ADDENDUM 4

ADDENDUM DATE: July 16th, 2019

PROJECT: Asheboro City Schools – HVAC Installation - Gymnasiums
Asheboro, NC 27203

1 ROOF PLAN- NAMS - GYM
A1-31A 1/8" = 1'-0"

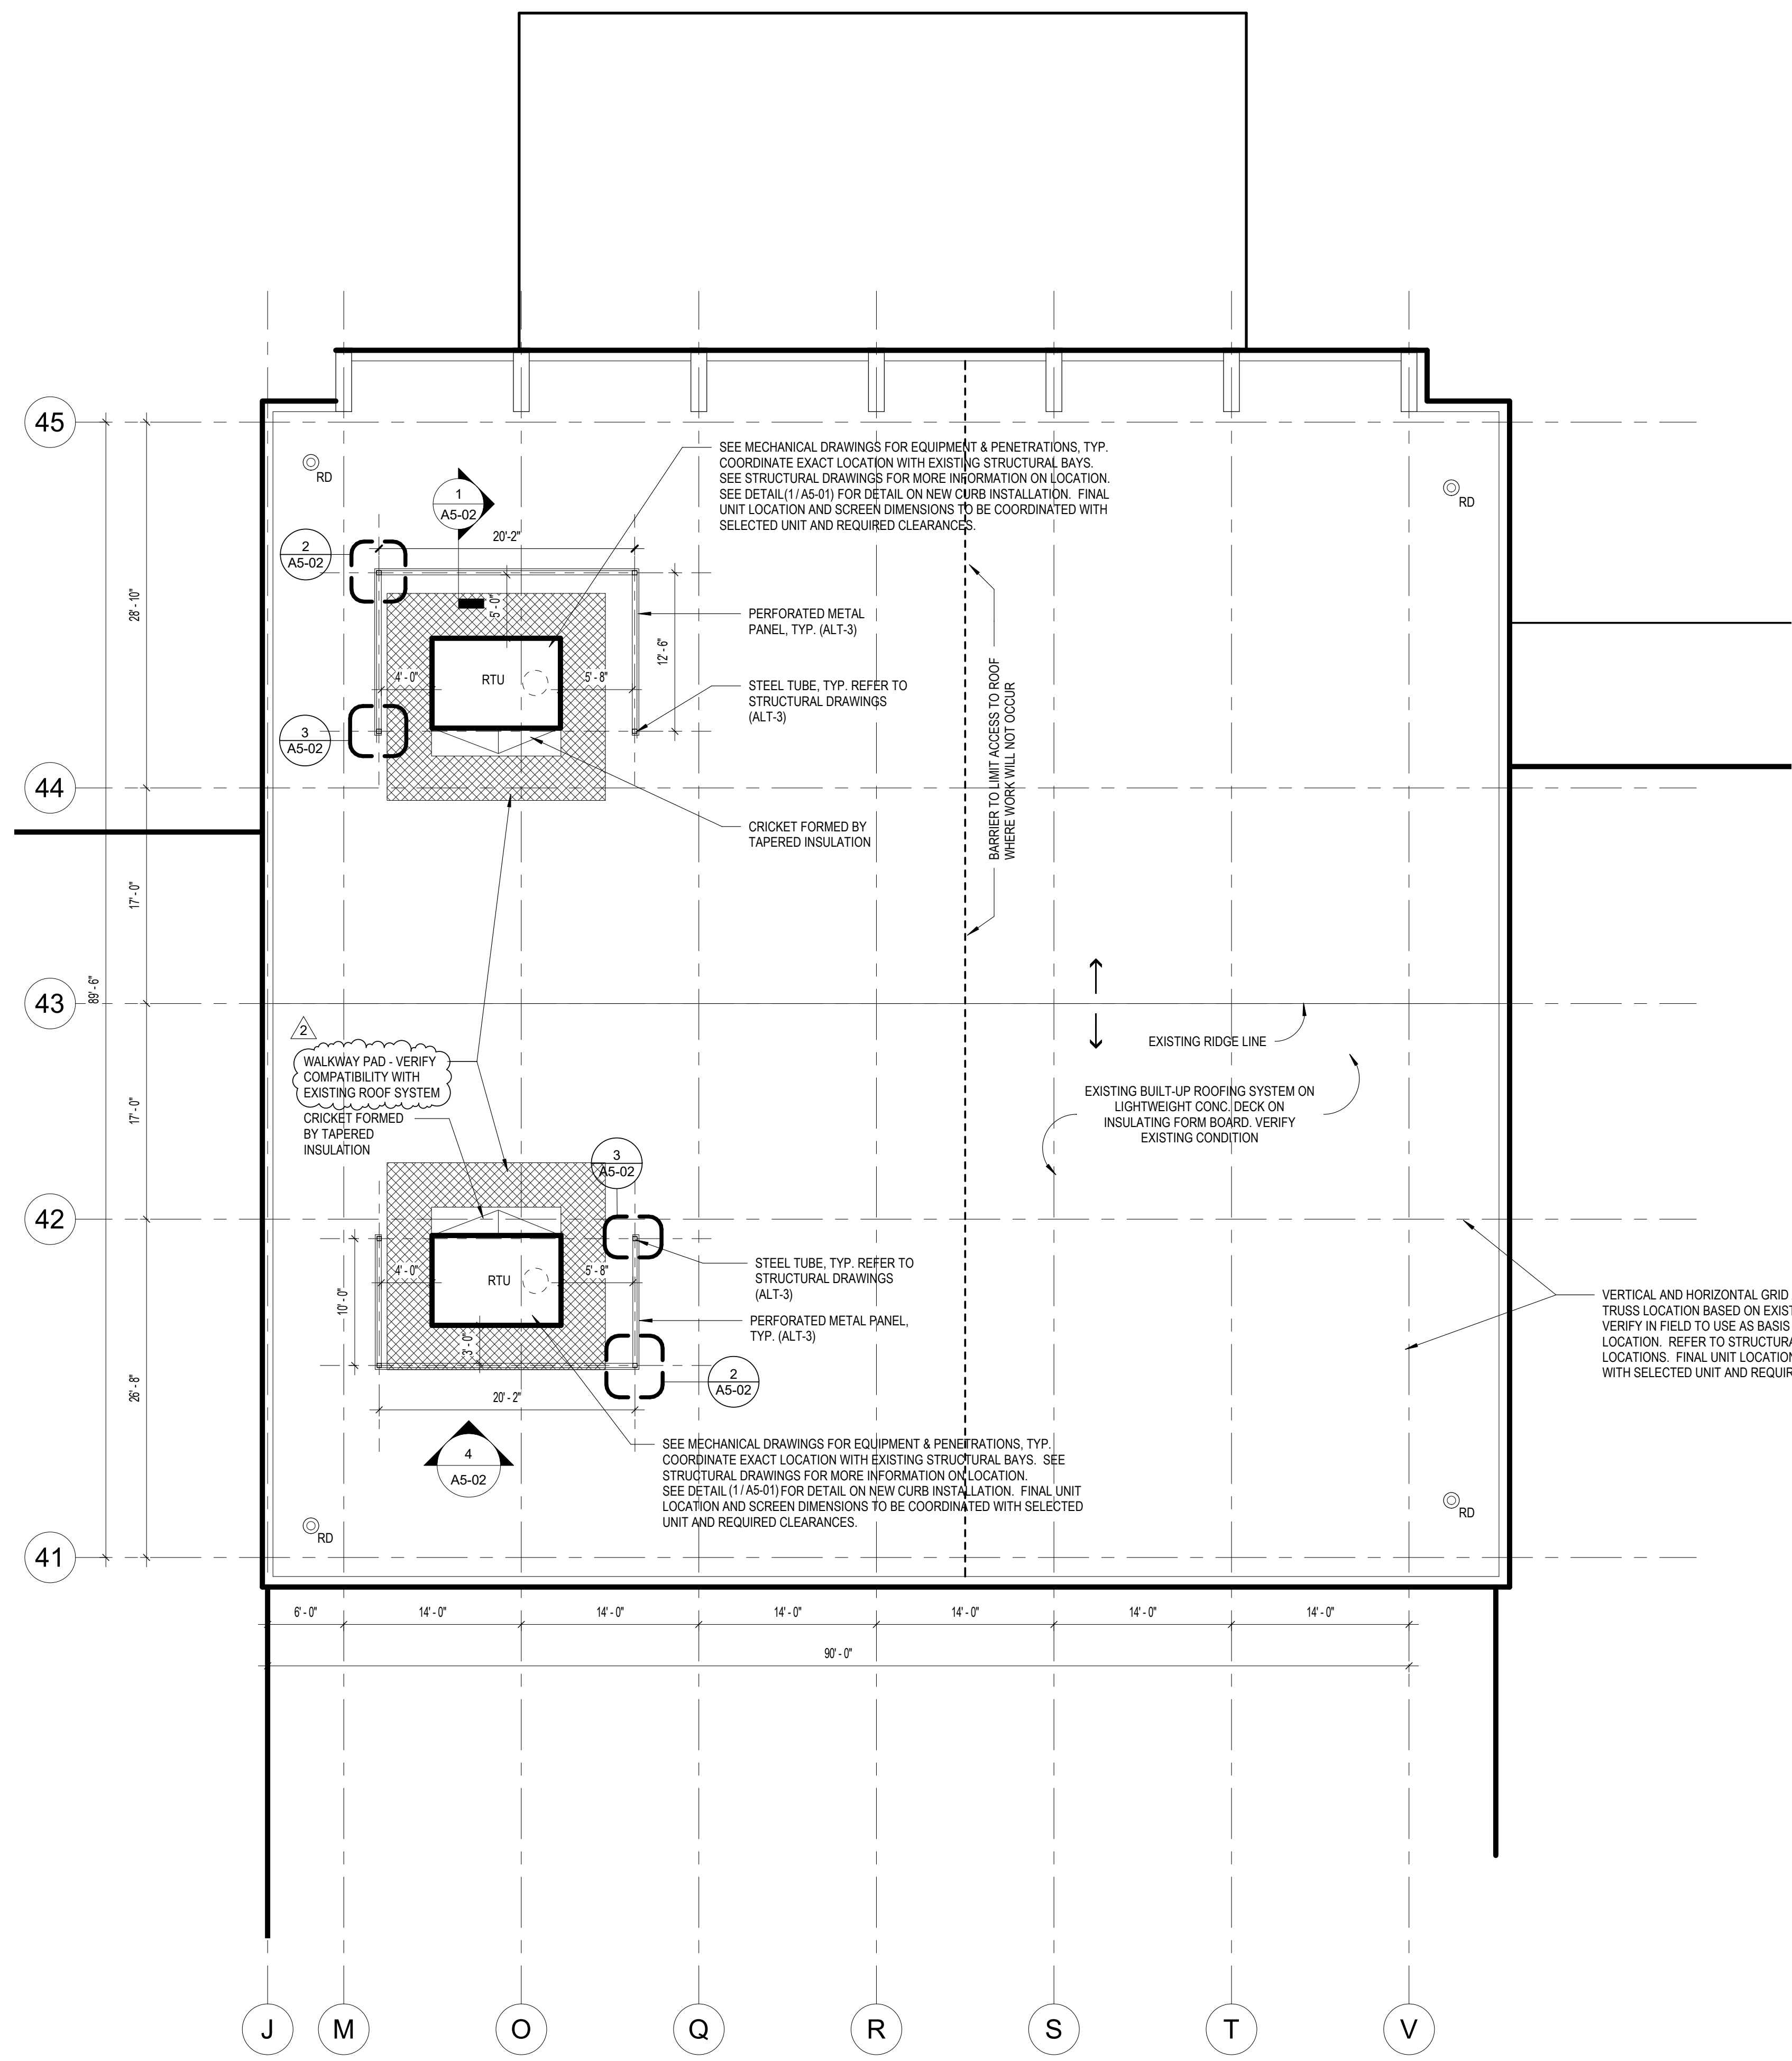
- Item 4 **REPLACE:** Sheet A1-31A - Roof Plan - NAMS. Revised sheet provides walkway pads around new HVAC Rooftop Units at North Asheboro Middle School.

**ELECTRICAL PLAN -
NEW WORK - NAMS**

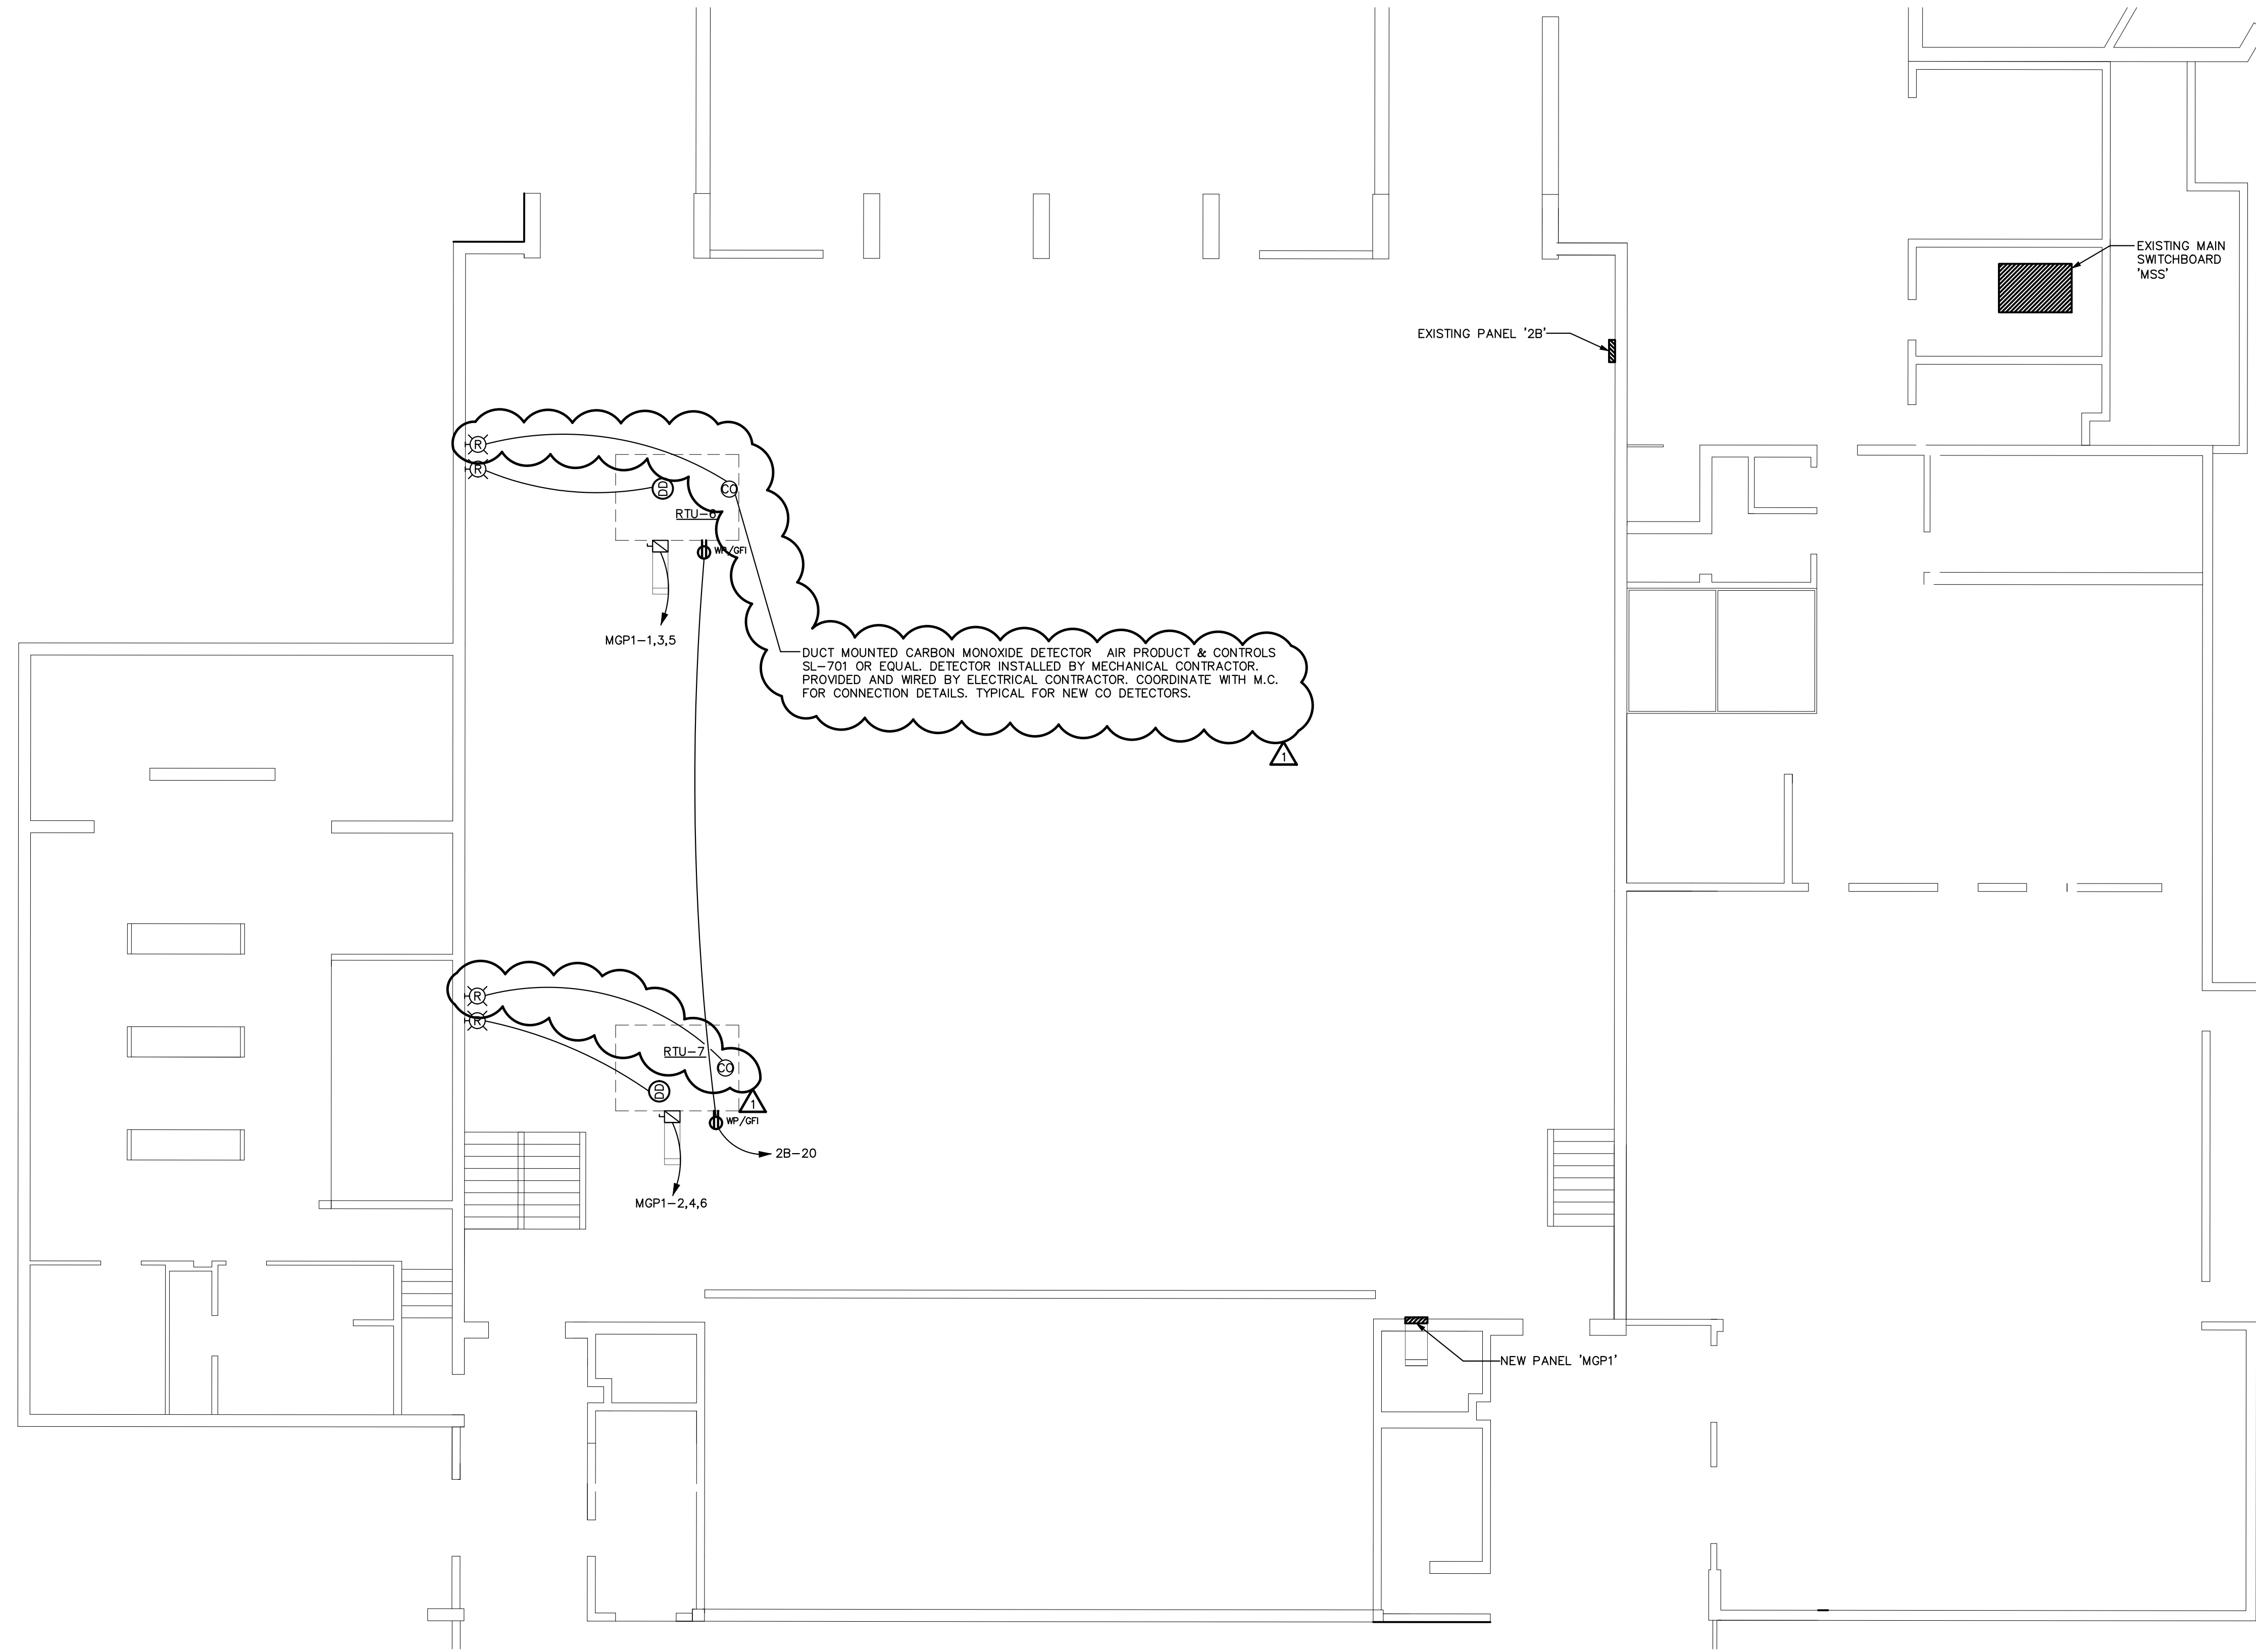
- Item 5 **REPLACE:** Sheet E0-01, E0-11B, E1-11A, E1-11B, E1-11C, and E6-01. Revised sheets have removed the “Not for Construction...” note related to the metering of existing panel ‘AUD’. Data from the metering confirmed that this existing panel can meet the demands necessary to power HVAC Rooftop Units at South Asheboro Middle School. Revised sheets E0-01, E1-11A, E1-11B, and E1-11C also provide information on additional carbon monoxide detection and the existing fire alarm system.
